AMENDMENTS TO THE DRAWINGS

REMARKS

Fig. 3

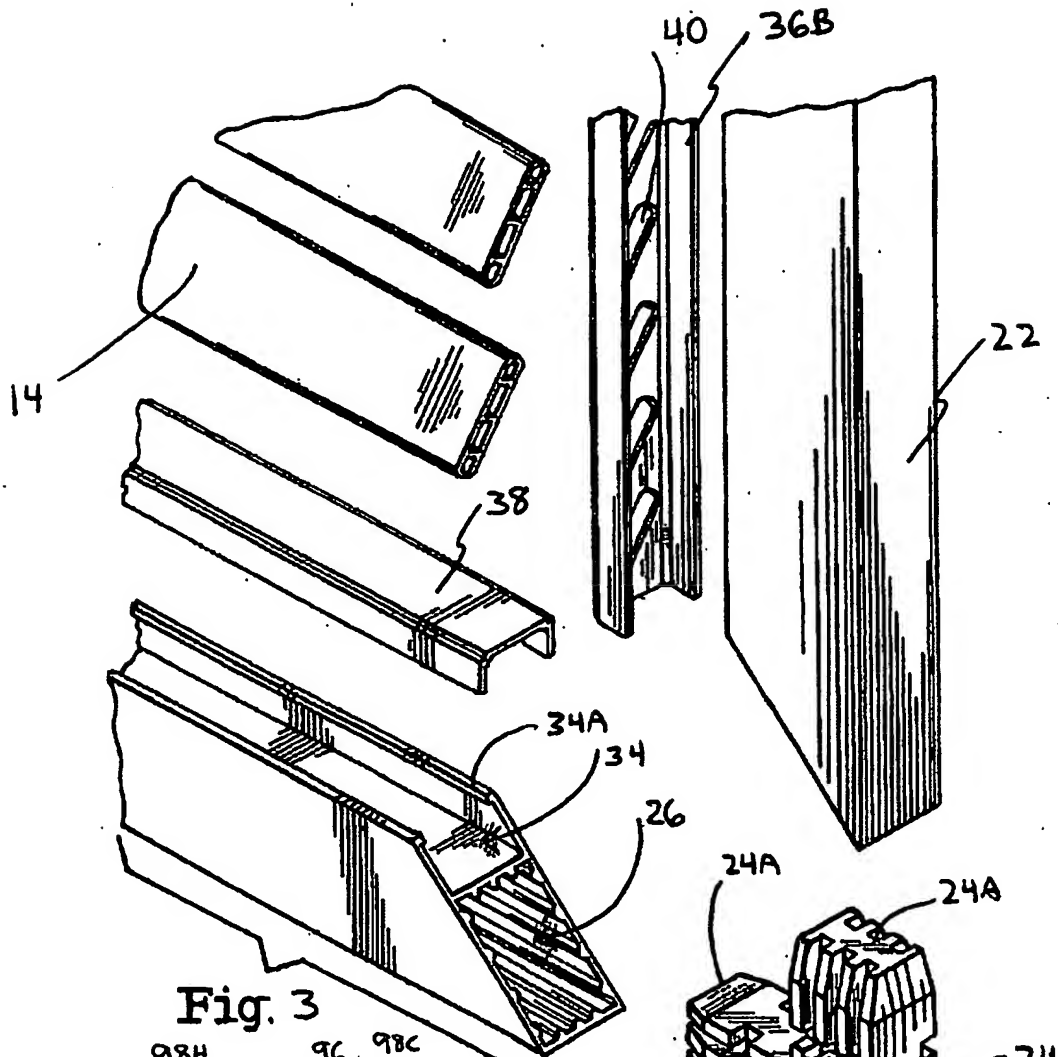
(4) The arrows at the ends of lead lines for reference numerals "26" and "34" in Fig. 3 have been deleted.

Fig. 14

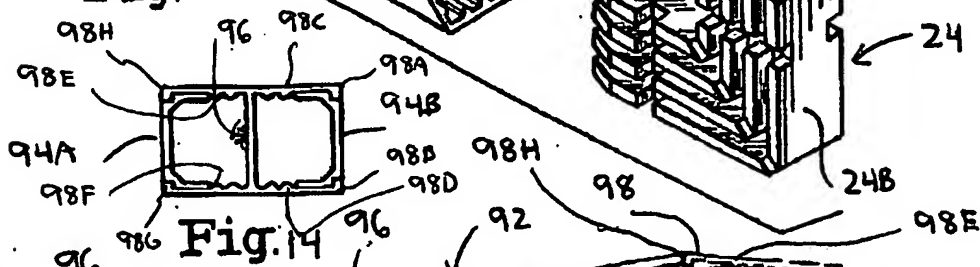
(12) The arrow at the end of the lead line for reference numeral "96" in Fig. 14 has been deleted.

Fig. 6

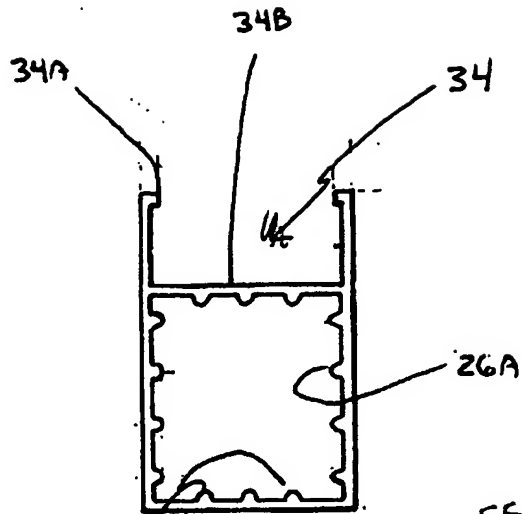
(7) The arrow at the end of the lead line for reference numeral "34" in Fig. 6 has been deleted.

Fig. 9

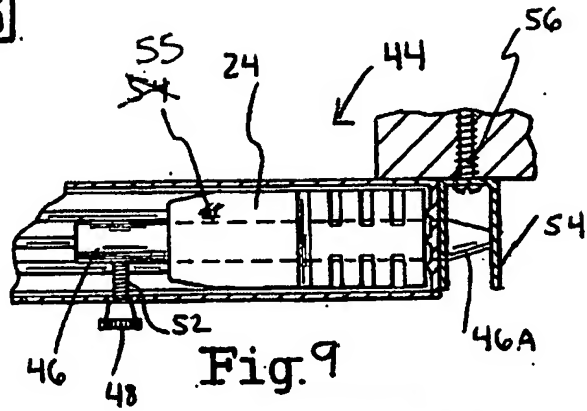
(9) The left-most occurrence of reference numeral "54" in Fig. 9 has been corrected to read "55", which is consistent with amended paragraph 0066 of the specification.

Regarding comment (1) at the first paragraph on page 8 of the Office Action, Applicants believe the Examiner is referring to Fig. 9 and not Fig. 6. As such, the left-most occurrence of reference numeral "54" in Fig. 9 has been corrected to read "55" to represent the "aperture through corner connector 24", which is consistent with amended paragraph 0066 of the specification. The right-most occurrence of reference numeral "54" correctly identifies the "latch pin receiver".

Fig. 4

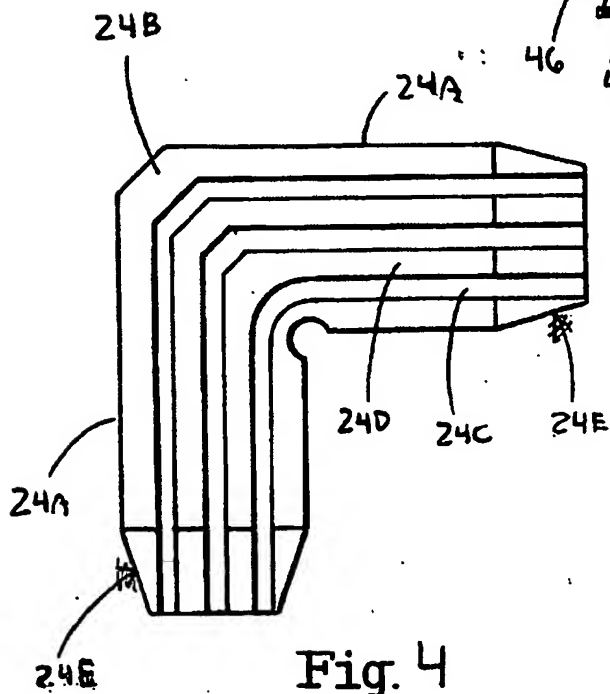
(5) The arrows at the ends of lead lines for both occurrences of reference numeral "24E" in Fig. 4 have been deleted.

Fig. 5

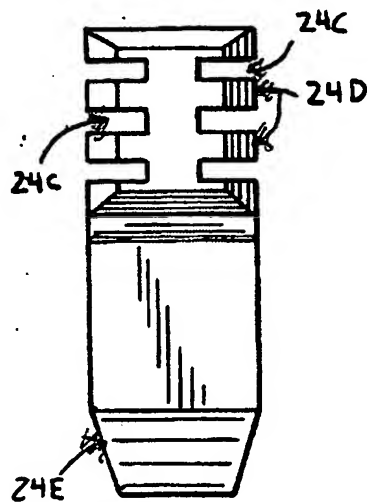
(6) The arrows at the ends of lead lines for reference numerals "24C", "24D" and "24E" in Fig. 5 have been deleted.

FIG. 18

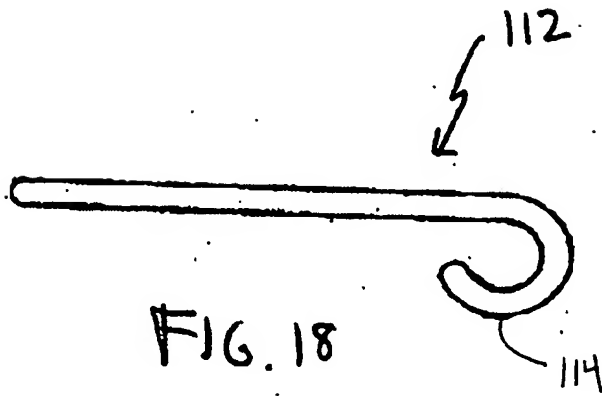
(2) Reference numeral "114" has been added to Fig. 18 to comply with the Examiner's requirements that the drawings show a "hinge member" as in paragraph 0081 of the specification.

Fig. 15

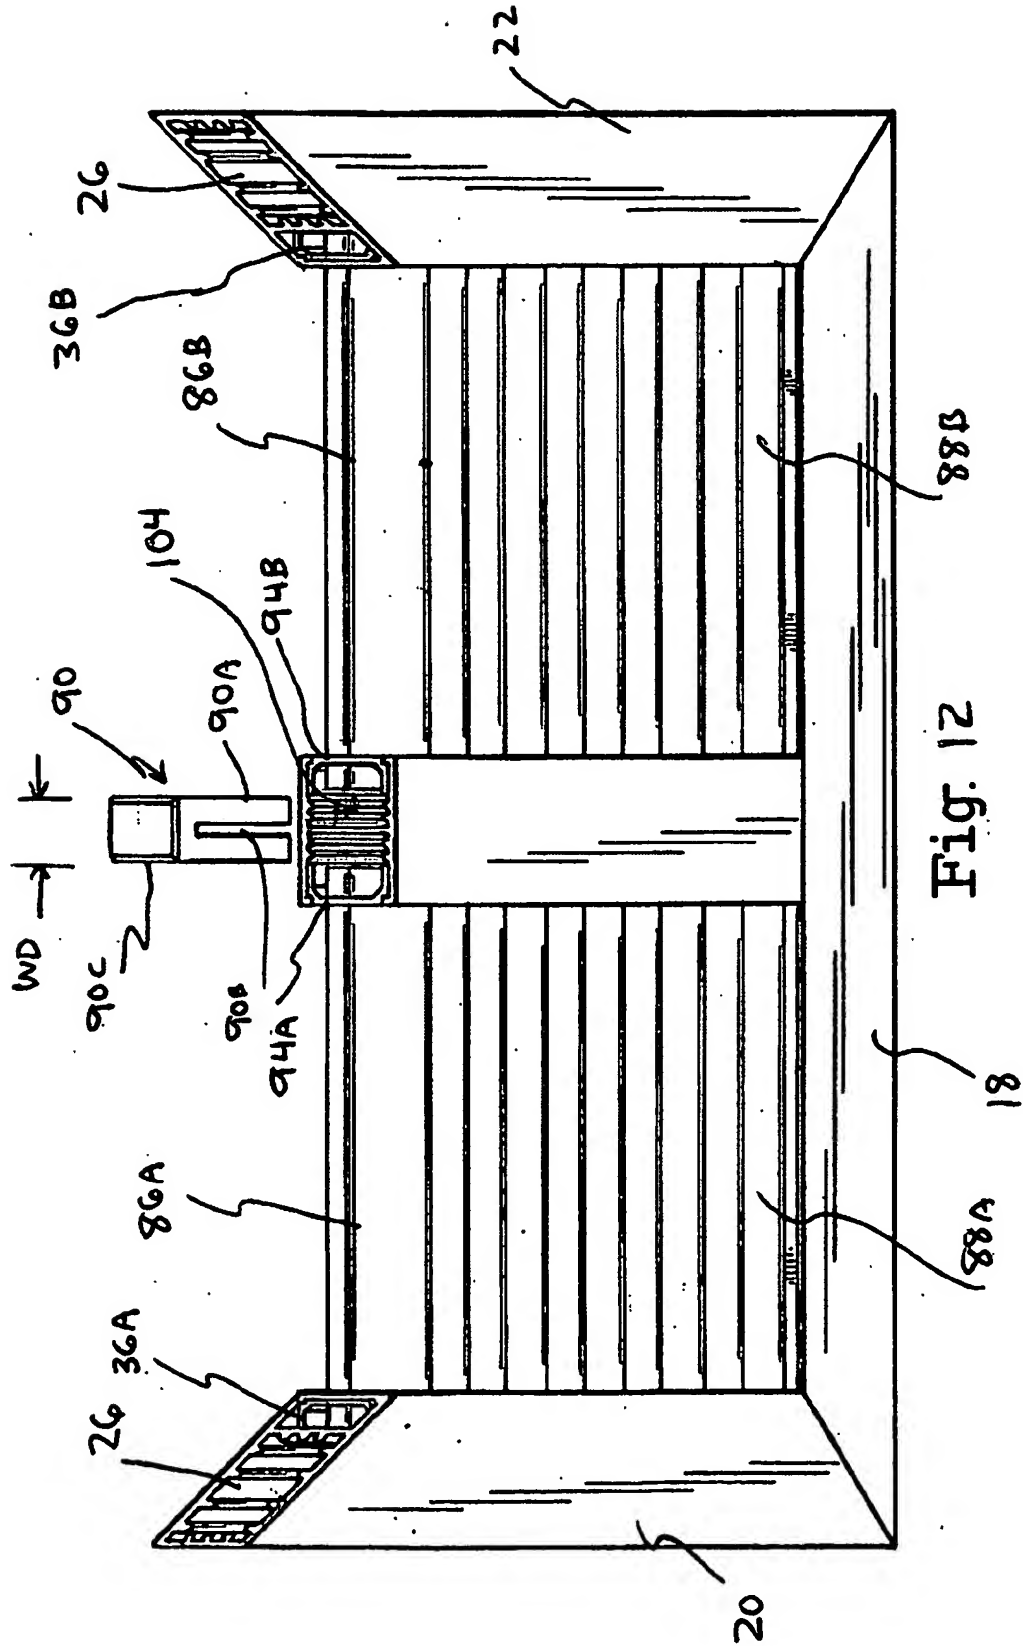
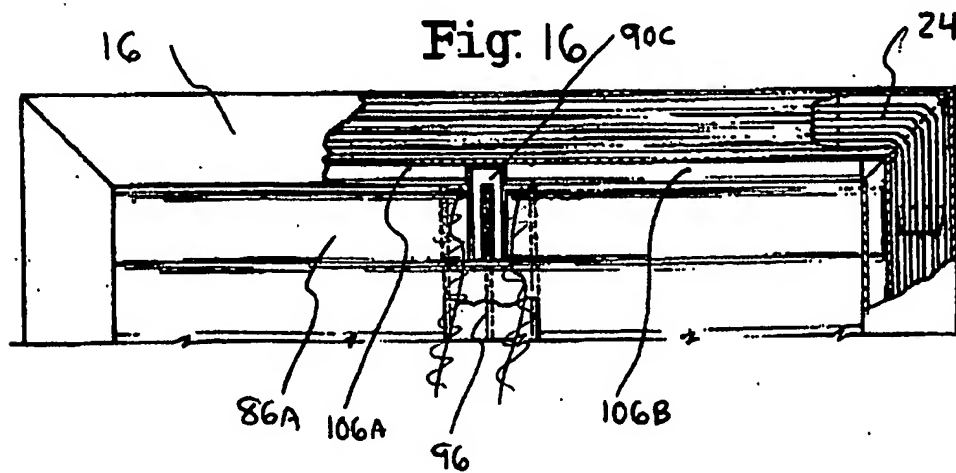
(13) The Fig. 15 appearing on the same sheet as Fig. 16 in the original drawings has been deleted, as it was a partial duplicate of the Fig. 15 with more reference numerals, which appeared on the last sheet of the original drawings. The Fig. 15 with more reference numerals, which appeared on the last sheet of the original drawings, has been kept and added to the sheet with Fig. 16, as suggested by the Examiner.

Fig. 16

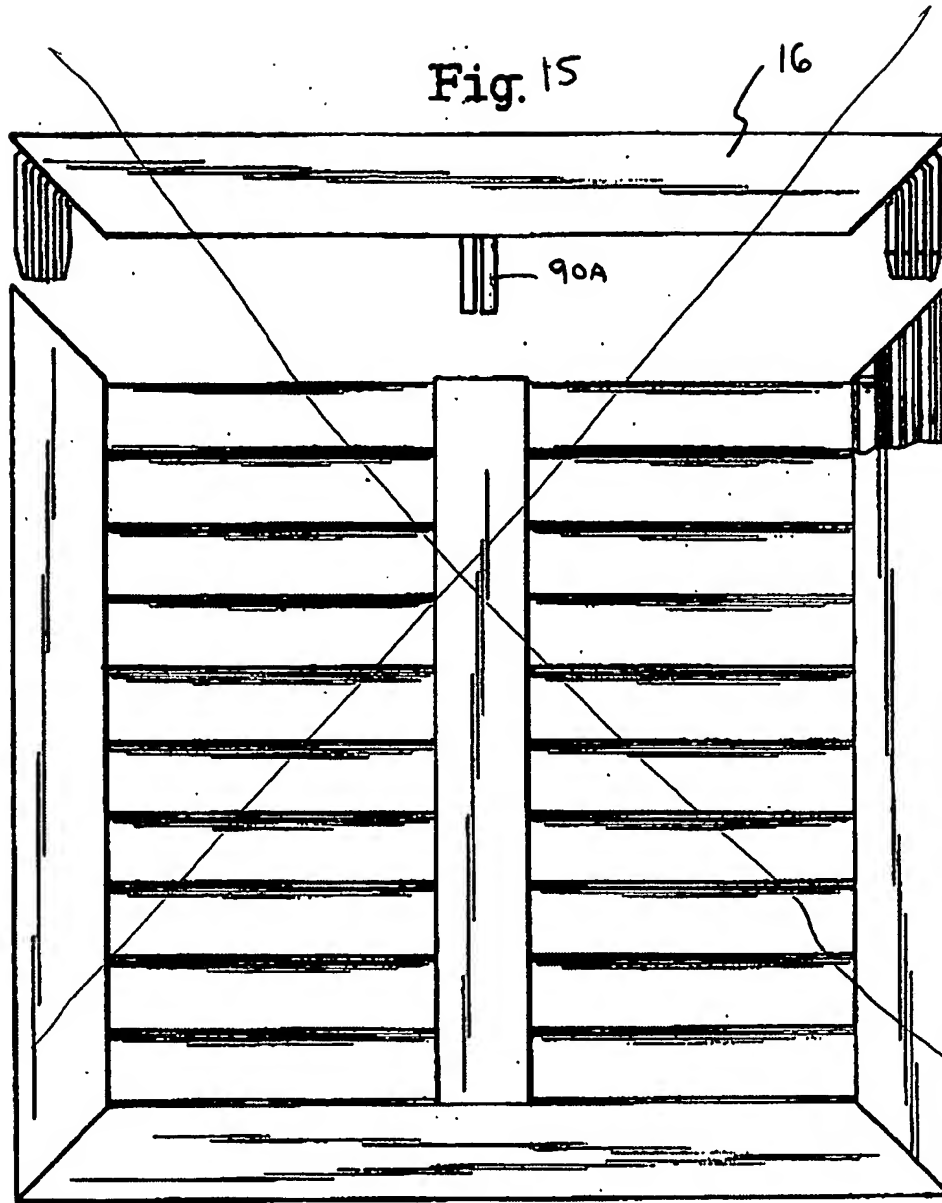
Additionally, the two extraneous lead lines surrounding reference numeral "96" in Fig. 16 have been removed.
